SUBJECT: NuScale Power, LLC Response to NRC Request for Additional Information No. 152 (eRAI No. 9047) on the NuScale Design Certification Application

NuScale Response to NRC Request for Additional Information eRAI No. 9047

NRC Question No.: 06.02.05-3

Figure 1 - Blast wave parameters for TNT explosion in air

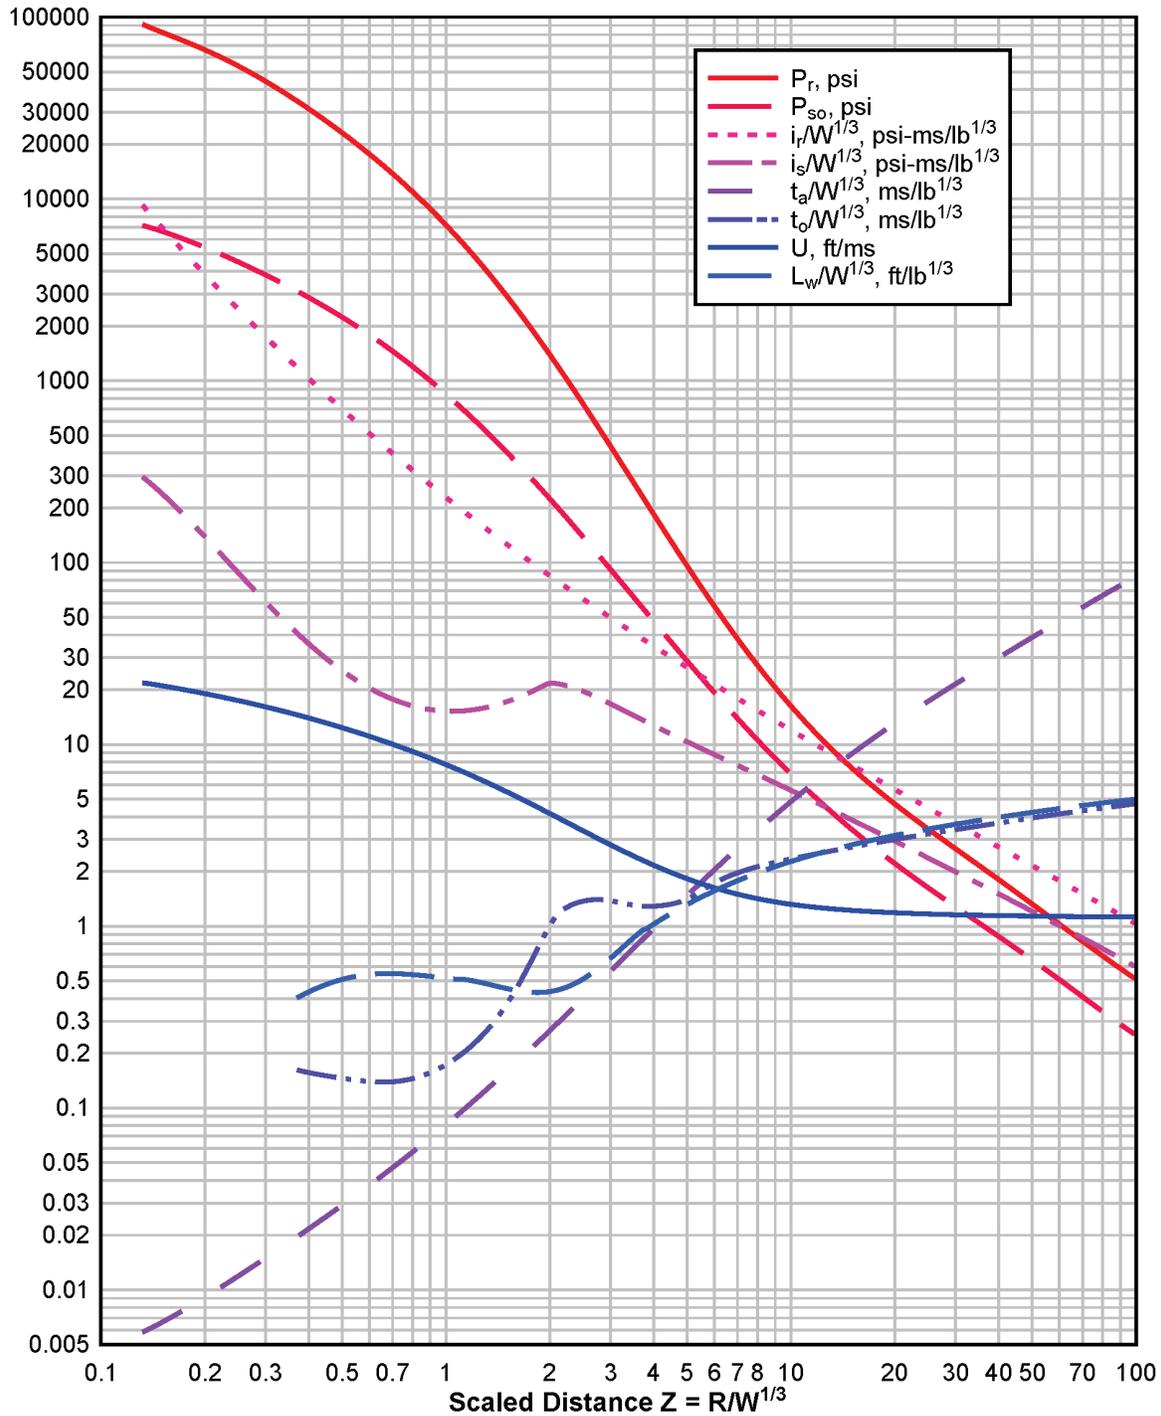
Additionally, the scaled distance parameter Z, which is used to determine the effective pulse impacts from the TNT-equivalent detonation, is based on the full containment vessel radius. The justification provided states that the “resulting pulse period is insensitive to this parameter over the majority of distances applicable for the CNV geometry”; while this may be valid for the pulse period, it is not valid for the pressure cited in Table 3-8 of the report. Given that such a distance is not feasible within the containment for most detonation/impact location pairs, this choice appears to be non-conservative. Further, the parameters calculated from the use of Z are based

on a TNT explosion in free air at sea level. The impact of the post-accident containment conditions as compared to free air on the calculated parameters is not assessed in the report.

Because the scaled distance, Z, is inversely proportional to the cube-root of the TNT mass (see Figure 1), the pulse-period or pulse-duration, t_d , is practically invariant for the range of yield efficiency factors from 0.01 to 0.10, as shown in Figure 2. Thus, using a yield efficiency factor of 0.05, as recommended by FM Global Datasheet 7-42, the resulting pulse-duration is 0.409 ms. Using a yield efficiency factor of 0.03, as employed in the NuScale calculations, the resulting pulse-duration is 0.414 ms (approximate 1% increase). Furthermore, if the yield efficiency factor were increased to 0.10, the pulse-duration would change slightly to 0.42 ms. Again, the overall effect of the cube-root scaling tends to maintain the pulse-duration invariant between yield efficiency factors of 0.01 and 0.10, thus making the choice of yield efficiency factor insignificant.

However, the overall distance travelled would be about 38 ft, resulting in a scaled distance, Z , of approximately $9.4 \text{ ft/lb}^{1/3}$, and peak reflected pressures of 20 psia (see Figure 1), which are not credible for gaseous detonations. As stated earlier, far-field effects are underpredicted when using the TNT-equivalent methodology and should be avoided. Therefore, the conservative approach in evaluating the CNV structural response is based on using the CNV radius to determine the pulse-duration, coupled with the peak reflected pressure based on C-J conditions of the gas mixture, not the peak reflected TNT-equivalent pressure. For smaller distances, e.g., below the CNV radius, a reduced pulse-duration is evident as shown in Figure 3. However, as

Extremely high pressures are generated from the TNT charge at very short distances, as evidenced by inspection of Figure 1. These extremely high pressures are not valid for gaseous detonations. For near-field detonations, TNT-equivalence methodology overpredicts peak pressures as compared with gaseous detonations. Gas phase detonations require a period of flame acceleration, wherein a deflagration from a low energy ignition source develops into a detonation front. Spatially, this is referred to as a run-up distance. TNT point source methodologies predict loads to increase with a cube function as the ignition source is approached. Due to this inconsistency between the core phenomena of short range TNT detonations vs short range gas phase combustion, estimation of loads using a TNT methodology at very short distances is not appropriate. Additionally, for close-in distances, DDT will not occur because a deflagration requires a significant run-up distance to create flame acceleration and transition to detonation, which cannot be accommodated at short distances.

Very low pressures result in TNT explosions at far distances, as evidenced by inspection of Figure 1. Far-field pressures from TNT blast curves cannot be relied upon for equating gaseous detonations because they decay at $1/R^2$ and expand the pulse-duration accordingly, resulting in unrealistic pressure and impulse.

Figure 2 - Pulse duration vs yield efficiency factor.

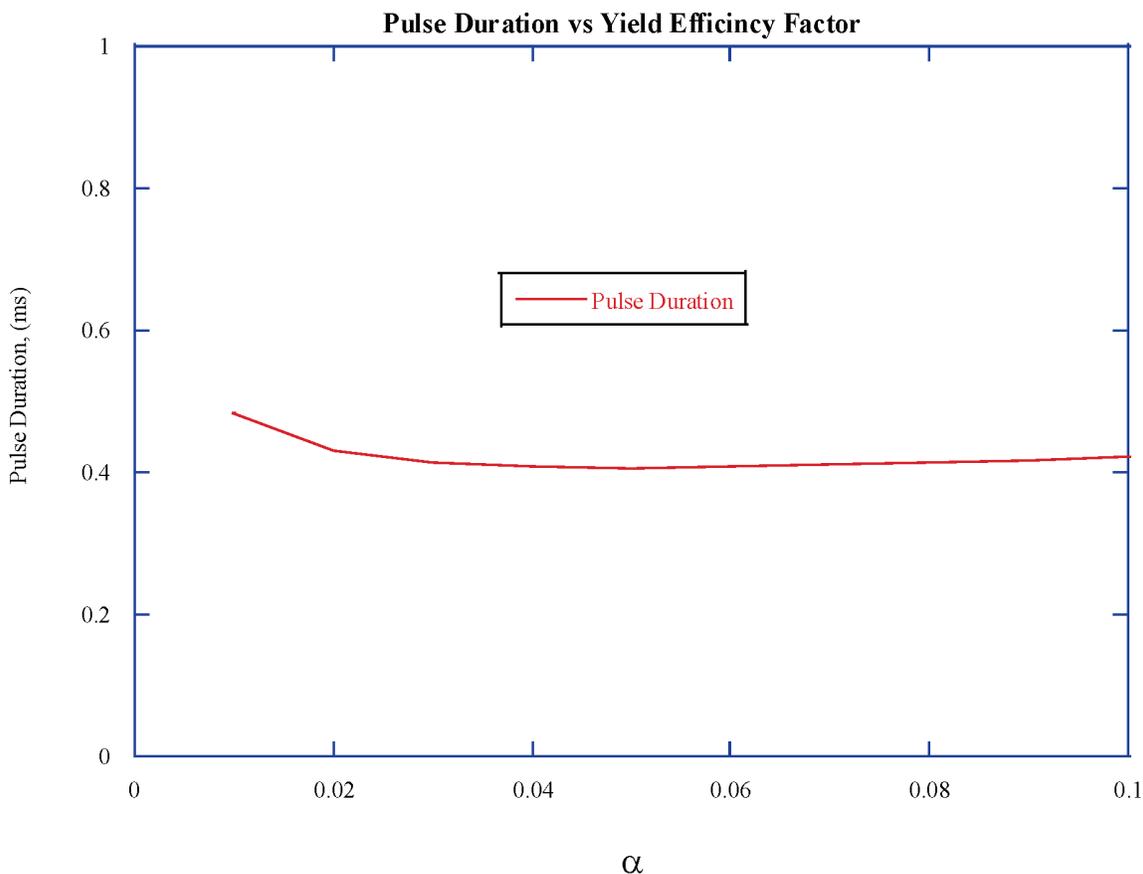
In TR-0716-50424, it is stated that the TNT equivalence method is used to calculate the pulse period, and the deflagration-to- detonation transition (DDT) pressure is used as the limiting combustion load. In the calculations performed in TR-0716-50424, the DDT pressure appears to be limiting. In the TNT-equivalence calculation performed as part of TR-0716-50424, a yield efficiency factor (α) of 0.03 was used, based on an industry reference “Guidelines for Evaluating the Effects of Vapor Cloud Explosions Using a TNT Equivalency Method”, which is available in ADAMS under accession number ML14224A361. In that source, a value of 0.05 (rather than the 0.03 used by NuScale) is recommended for hydrogen, but that this factor is based on a number of factors including layout. Both the source and NUREG-1805 note that level of confinement tends to increase the yield efficiency factor.
